**Seattle  
Design  
Commission**

**MINUTES OF THE MEETING**

**March 6, 2008**

**06 March 2008**      **Project:** CarrAmerica Highland Street Vacation

**Figure 3: Site Plan**

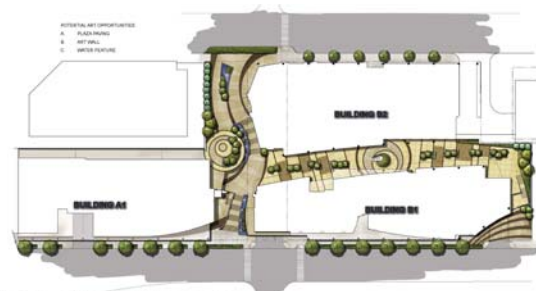
- **Appreciate the well designed plaza and stairs which are more prominent and visible than before.**
- **Curious about the art elements and urge the team to involve an artist in these early, critical phases of design**

- **The roofs are a considerable part of the view corridor and treatments, such as green roofs, should be considered.**
- **The garage entry seems uncomfortably large and the team should consider reducing the number of lanes.**

- **Review the sidewalk treatment through the driveway entrance to make sure the pedestrian environment is clearly delineated.**
- **The ratio of green to pavement seems skewed to the hardscape, recommends more balance.**

- **Incorporate more pausing space within the context of the large scale stairs and create a “balance of choices” to enhance the pedestrian experience.**
